Licence Number L5110/1988/10

Licence Holder Agnew Gold Mining Company Pty Ltd

Premises Lawlers Gold Mine

Amendment Notice

Map of Lawlers WWTP and Irrigation Area

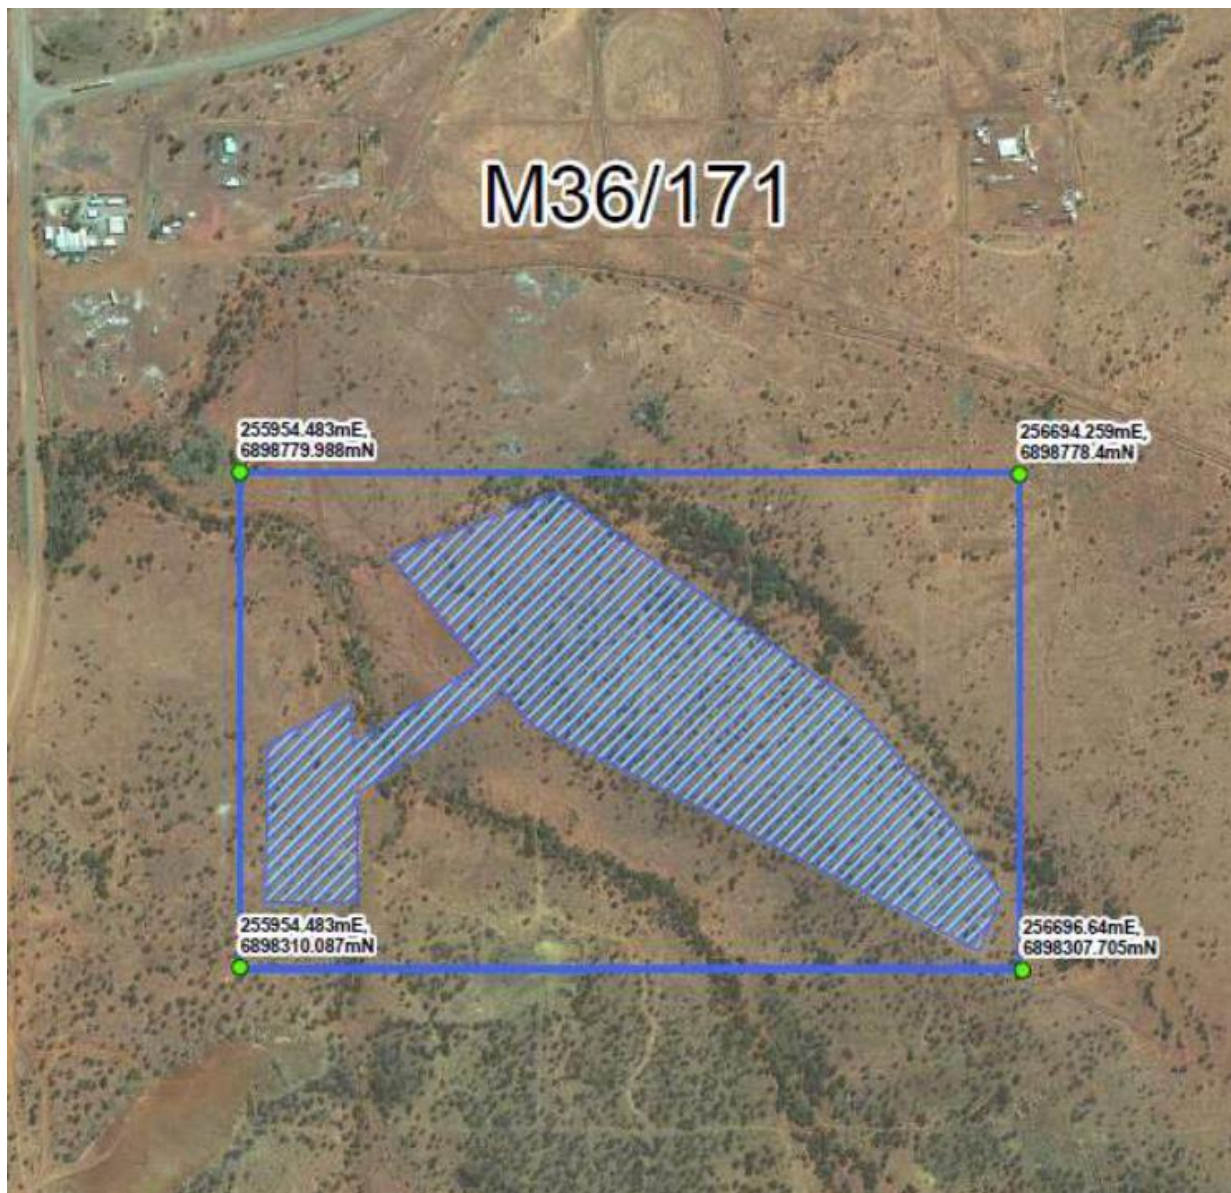
8. The Licence is amended by the insertion of the following Map into Schedule 1: Maps.
